DeltaSet – Oni Mask Keycap Set

Oni Mask 键帽套装 — 样品反馈 (Sample Feedback)

PO AM20260526 · Date 2026-05-31

Navy 1 – the marked caps show the navy we prefer (target for the whole set).

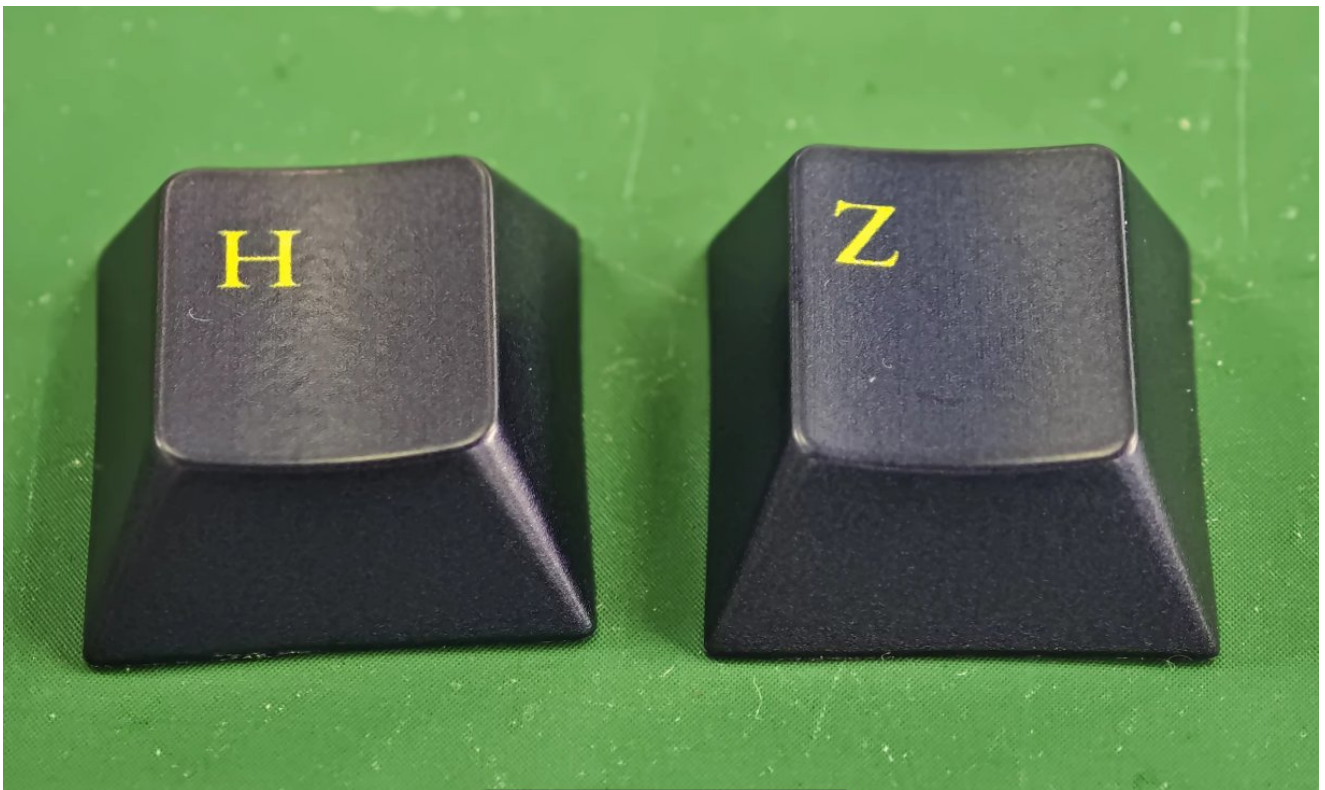
- 1 About the blue (navy): we can see the blue is not the same on all caps, and we understand it is not a lighting issue. We prefer the deeper, more even navy. Please use that as the target for the whole set so all caps match. Reference: the caps marked in the photos, and the "Z" cap ("Z" is the target, "H" is the off one).

关于蓝色 (navy)：我们能看出不是所有键帽的蓝色都一样，也明白这不是灯光问题。我们更喜欢更深、更均匀的那种 navy。请以它作为整套的目标颜色，让所有键帽保持一致。参考：照片里标记的键帽，以及 "Z" 键 ("Z" 是目标，"H" 是偏色的那个)。
